PUBLIC INTEREST TECHNICAL REVIEW FOR GROUNDWATER APPLICATIONS

TO: Water Rights Section Date: 8/21/2025
FROM: Groundwater Section Grayson Fish
Reviewer's Name
SUBJECT: Application G - 19512 Supersedes review of _____

Applicant's Name: 3MC Ranches LLC County: Klamath
Applicant(s) seek(s) 1.11 cfs from 1 well(s) in the Klamath Basin,
Eastern Lost River subbasin
Proposed use Primary Irrigation (10 Acres) Seasonality: March 1 – October 31

Figure 1: Well Location Map

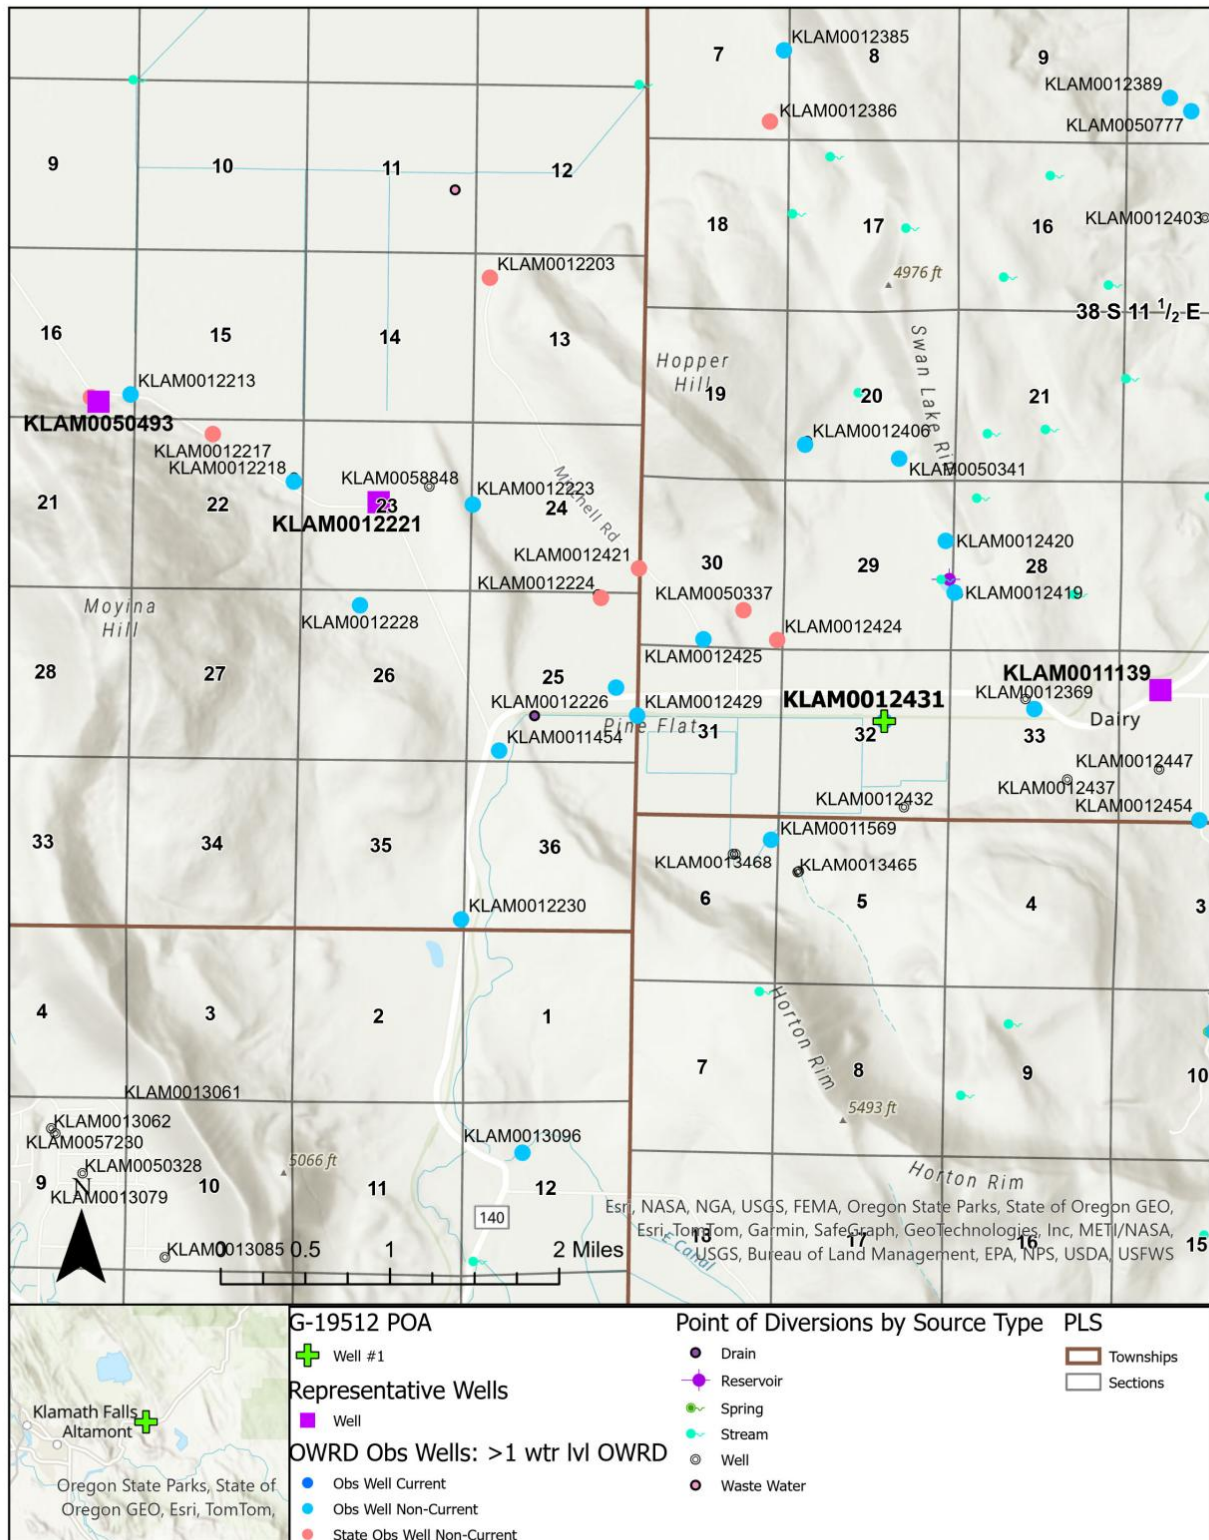
A3. Description of hydrogeologic setting / conceptual model: The proposed POA Well #1 (KLAM 12431) is located in the Pine Flat area of the Eastern Lost River Sub-basin of the Klamath Basin and is approximately 1.5 miles west of the town of Dairy (**Figure 1 – Well Location Map**). The location of Well #1 puts it within the Swan Lake Valley to Poe Valley sub-area as defined in *Groundwater in the Eastern Lost River Sub-basin, Langell, Yonna, Swan Lake, and Poe Valleys of Southeastern Klamath County, Oregon* (Grondin, 2004). The groundwater gradient is relatively flat in central Pine Flat but does indicate flow to the southwest in the western portion of Pine Flat. A steeper groundwater gradient exists along the southwestern edge of Swan Lake Valley with groundwater elevations that are 10 to 15 feet lower than those in the central portion of Pine Flat. Water level data indicates that the central portion of this subarea has the most direct connection to the Lost River and that faults in southwest Swan Lake Valley and west Pine Flat facilitate groundwater drainage toward northwest Poe Valley. Groundwater discharges from the sub-area to the Lost River via springs in western Poe Valley (Grondin, 2004).

Figure 2 – Area Hydrographs

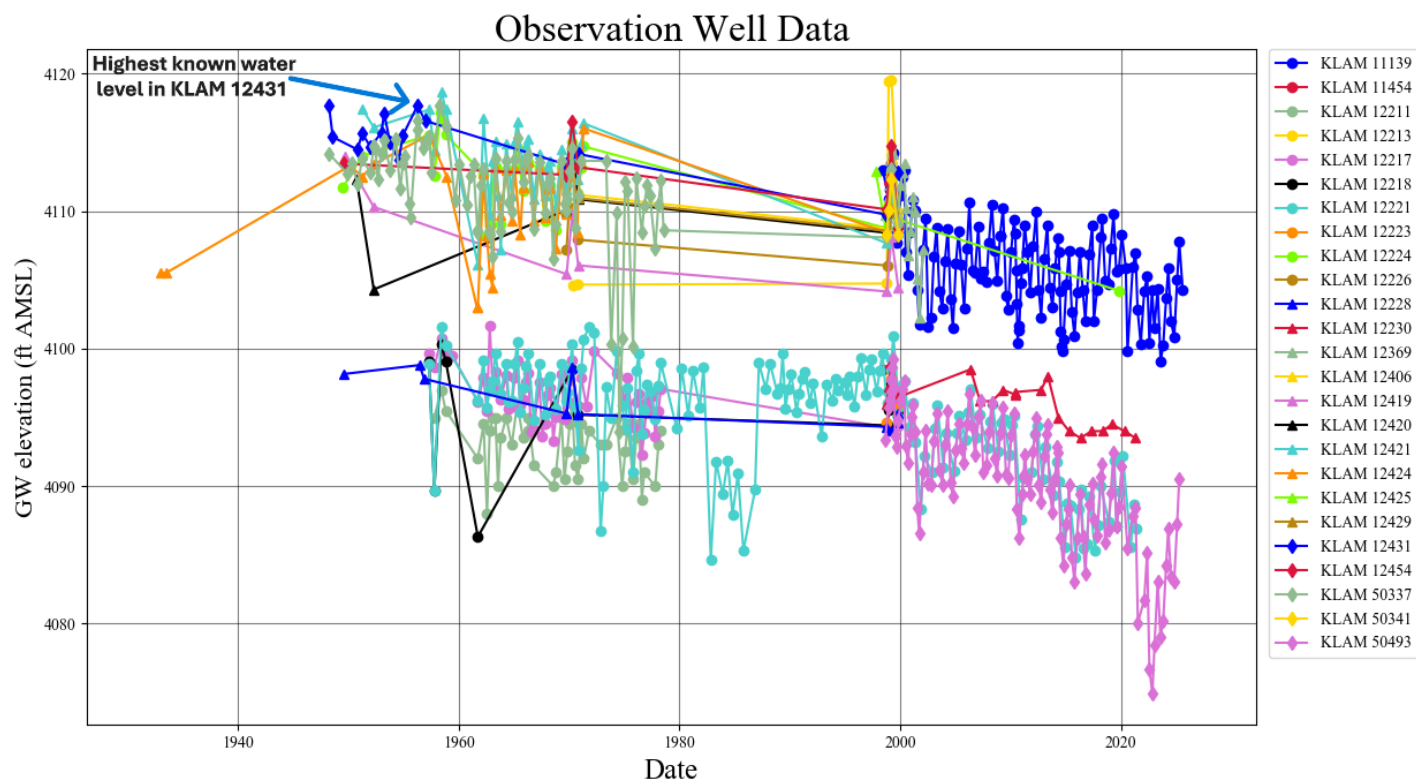
The year 2001 saw an increase in groundwater pumping for irrigation within the Bureau of Reclamation Klamath Project due to changes in surface-water management and drought which resulted in a less surface water available to Project irrigators (Gannett et. al., 2007). This shift to groundwater use resulted in declining groundwater levels at varying magnitudes throughout the project area. Hydrographs from observation wells located in Pine Flat and Swan Lake Valley show groundwater declines between 5 and 10 feet between spring of 2000 and 2025. Groundwater levels in this portion of the Eastern Lost River subbasin appeared to be in a state of dynamic equilibrium prior to the year 2000 (**Figure 2 – Area Hydrographs**).

Figure 3 – Representative wells

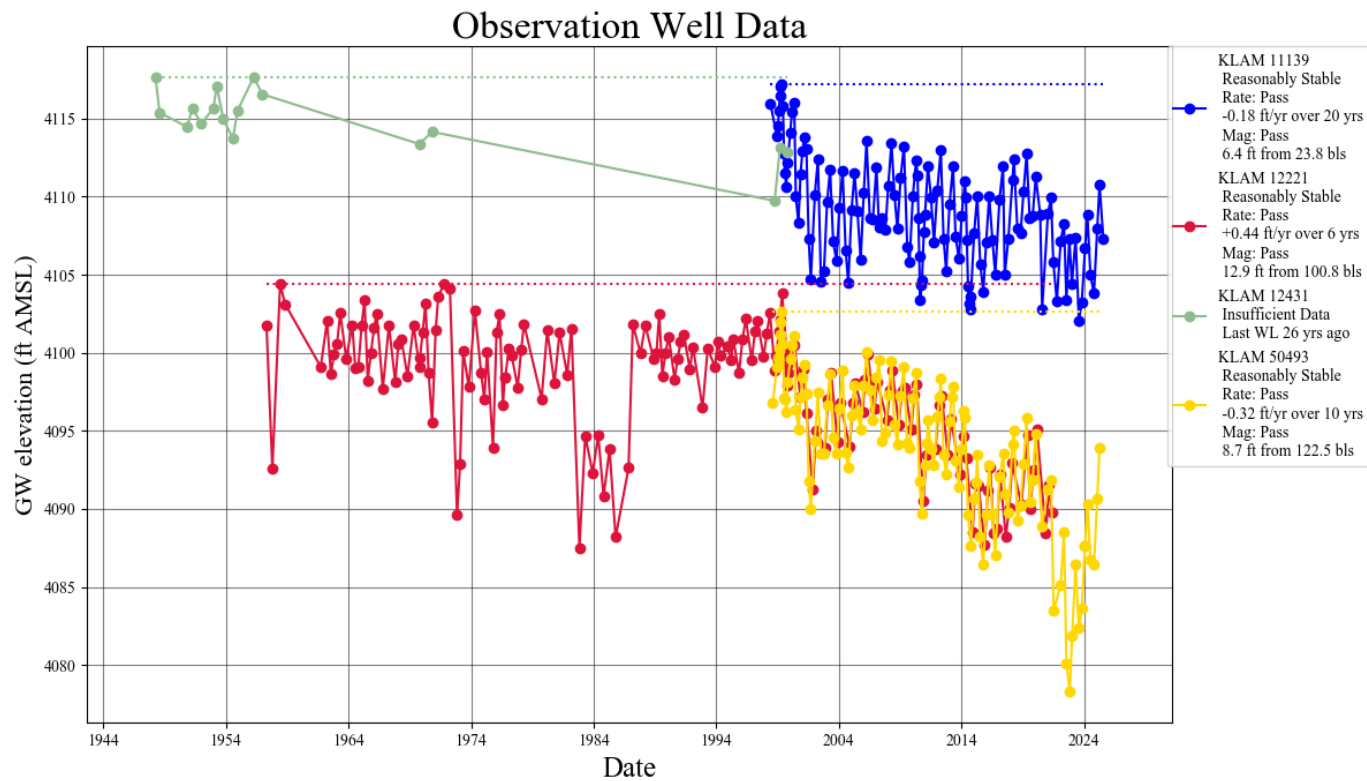
Three representative wells were identified to evaluate if water levels in the groundwater reservoir are reasonably stable (Figure 3 – Representative Wells). Discussion of these wells follows:

Figure 4 – Wells with higher water level elevations

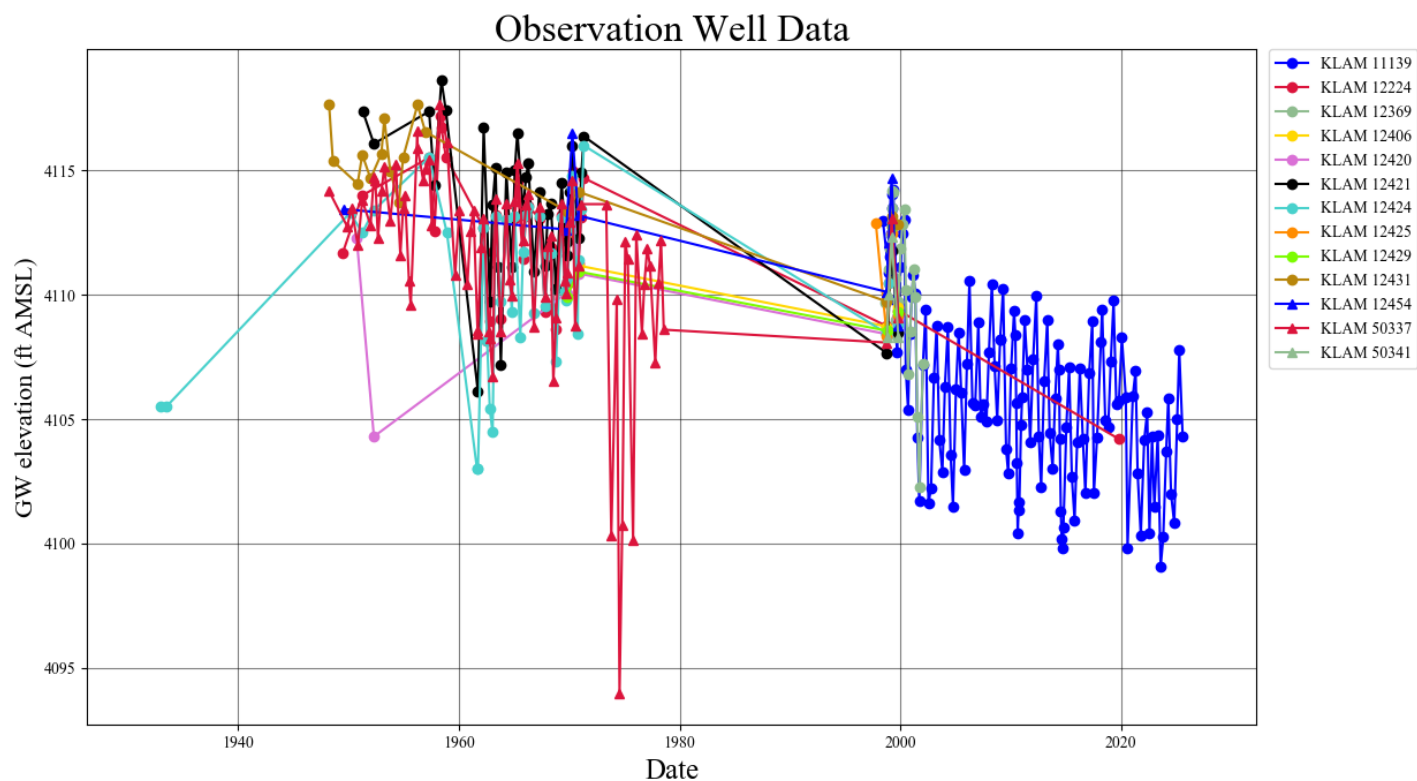
- KLAM 11139 is a 125 feet deep observation well located approximately 1.6 miles east of Well #1. This well sources water from “cinder and pumice” and has a noted yield of 10 gpm. Despite being relatively shallow and low yielding, groundwater elevations in this well are similar to other wells in Pine Flat around the year 2000 when period of records for these wells overlapped (Figure 4 – Wells with higher water level elevations).

Figure 5 – Hydrograph for KLAM 11139

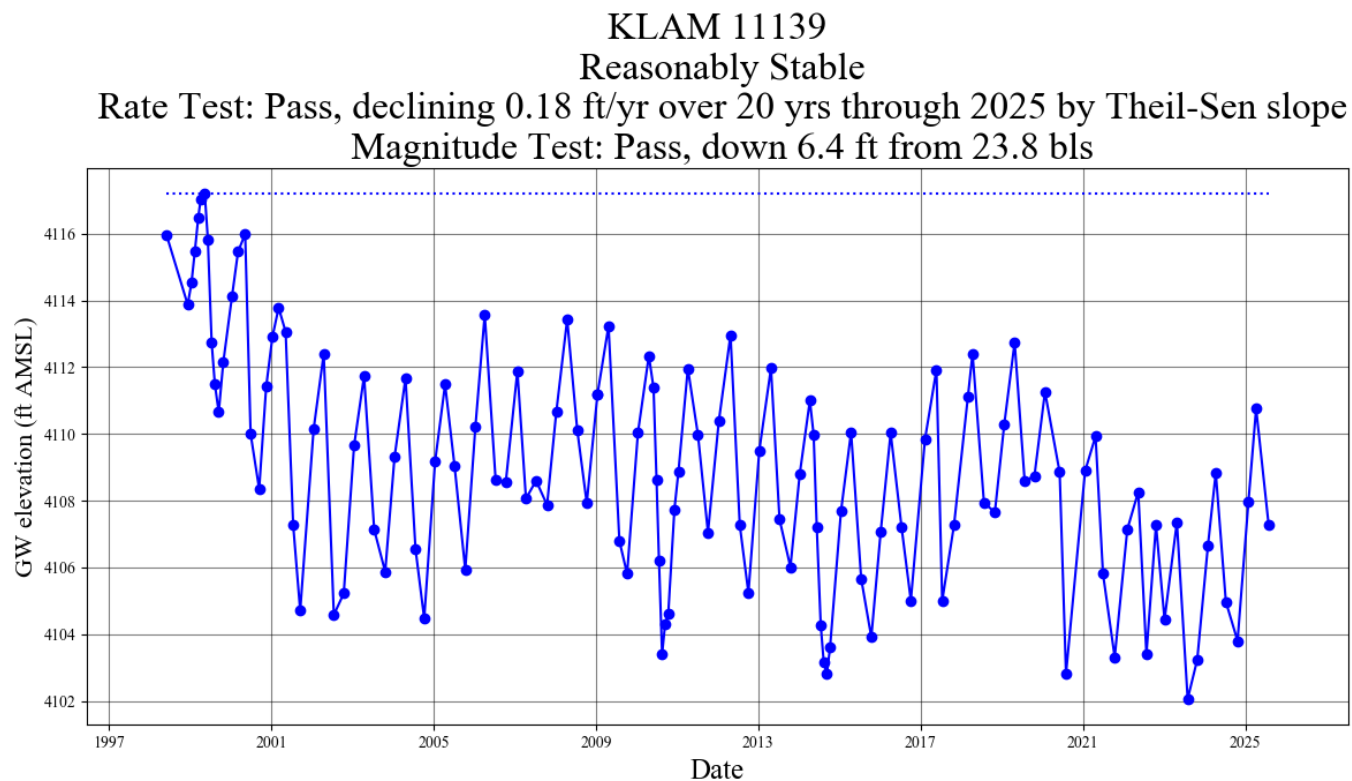
Water level data from KLAM 11139 passes the Rate and Magnitude tests, indicating water levels are reasonable stable (Figure 5 – Hydrograph for KLAM 11139).

Figure 6 – Hydrograph for KLAM 12221

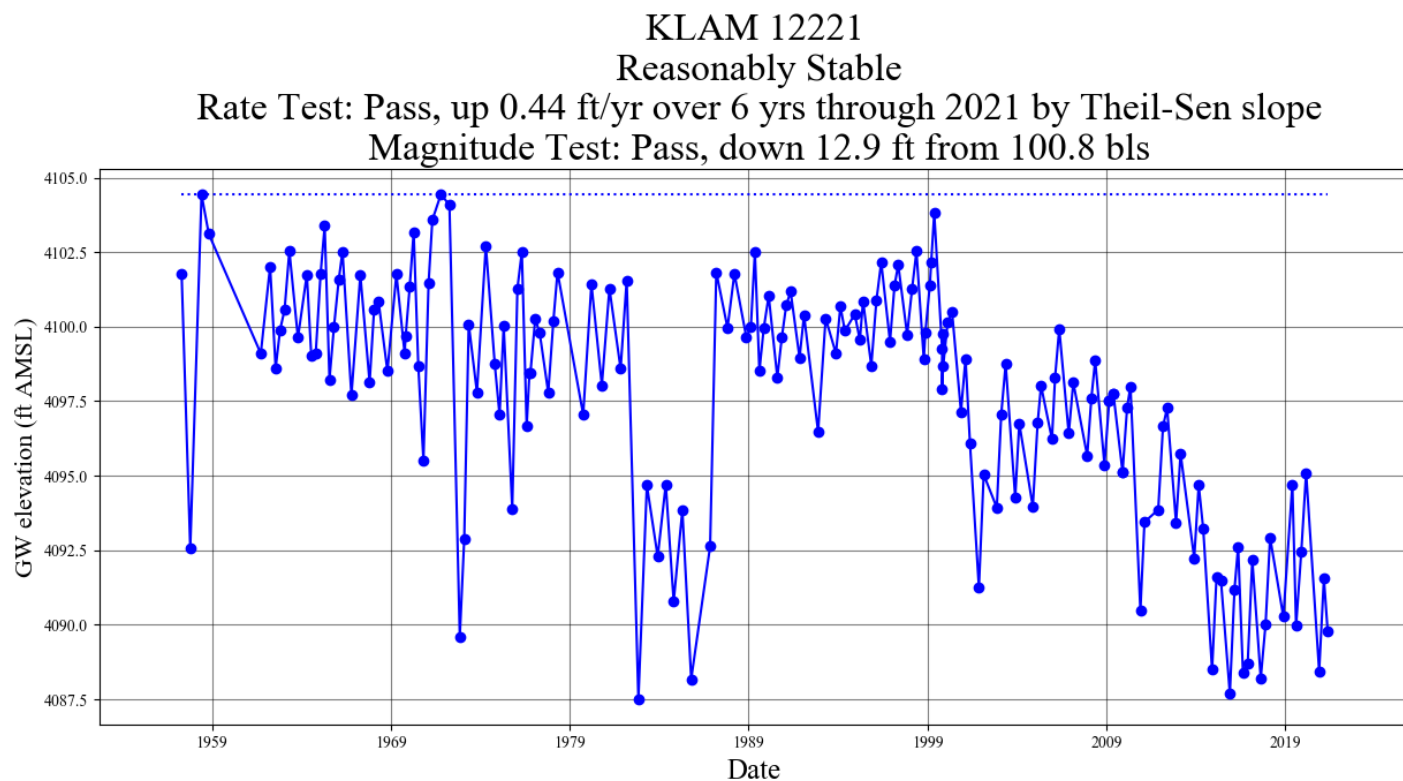
- KLAM 12221 is a 260 feet deep irrigation well located 3.25 miles northwest of Well #1. KLAM 12221 sources water from basalt starting at a depth of 200 feet and has a water level measurement period of record from 1957 to 2021. Groundwater elevations are approximately 5 to 10 feet lower in this well compared to Well #1 when periods of record overlap. Despite the differing groundwater elevations, the general water level trend of KLAM 12221 matches that of other basalt wells in in the southern Swan Lake Valley and Pine Flat area and is considered representative of the groundwater reservoir that Well #1 sources water from. Water level data from KLAM 12221 passes the Rate and Magnitude tests, indicating water levels are Reasonably Stable (Figure 6 – Hydrograph for KLAM 12221).

Figure 7 – Hydrograph for KLAM 50493

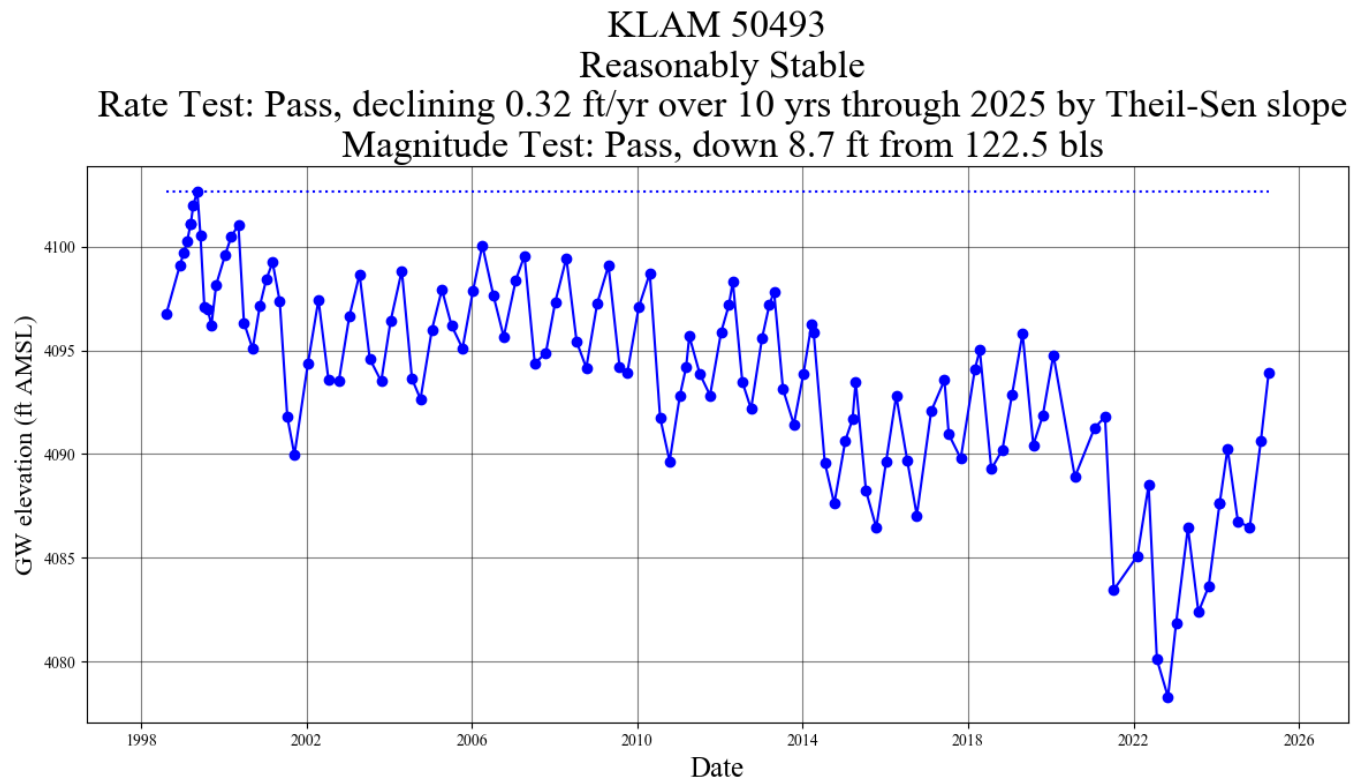
- KLAM 50493 is a 206 feet deep domestic well located 5 miles northwest of Well #1 and 1.75 miles west of KLAM 12221. KLAM 50493 encounters basalt at 156 feet below land surface and elevations of groundwater levels measured at the well are very similar to KLAM 12221. Recent water level measurements have been collected from KLAM 50493 and this well acts as an extension of KLAM 12221's period of record. Water level data from KLAM 50493 passes the Rate and Magnitude tests, indicating water levels are Reasonably Stable (Figure 7 – Hydrograph for KLAM 50493).

Attachment 1 – Theis Time-Drawdown**Theis Time-Drawdown Worksheet** v.5.00

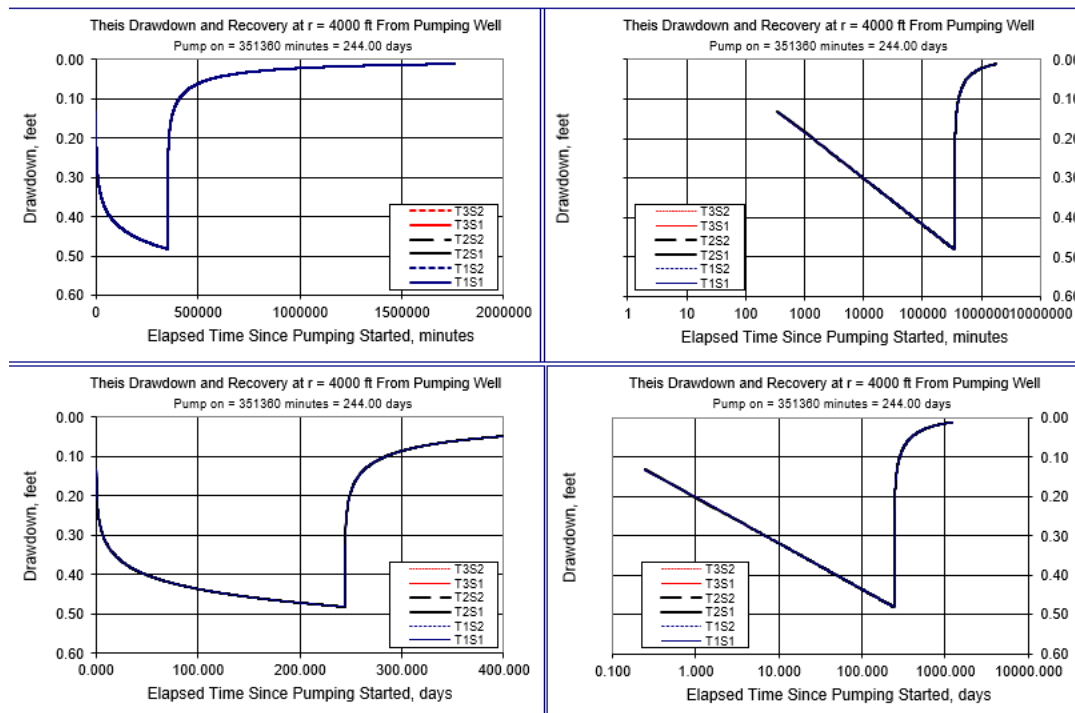
Comments: The closest authorized groundwater point of appropriation is KLAM 12424 associated with Certificate 42502 and is located approximately 4,000 feet northwest of Well #1. The reported depth of KLAM 12424 is 145 feet with a static water level of 81.70 feet below land surface as of 10/26/1999. The Theis time-drawdown equation (Theis, 1935) was used to estimate drawdown associated with Well #1. A transmissivity value of 150,000 ft²/day and a storage coefficient of 0.00040 for the Central portion of the Swan Lake to Poe Valley subarea were used for aquifer parameters (Grondin, 2004). At the maximum proposed rate of 1.11 cfs for 244 days, the estimated drawdown 4,000 feet from Well #1 is less than 0.5 feet (Attachment 1). The expected interference that would result from the additional proposed rate requested by this application is not expected to result in substantial or undue interference with an existing groundwater user if conditioned as indicated in item F below.

7RLA, 7J, Large water use reporting.
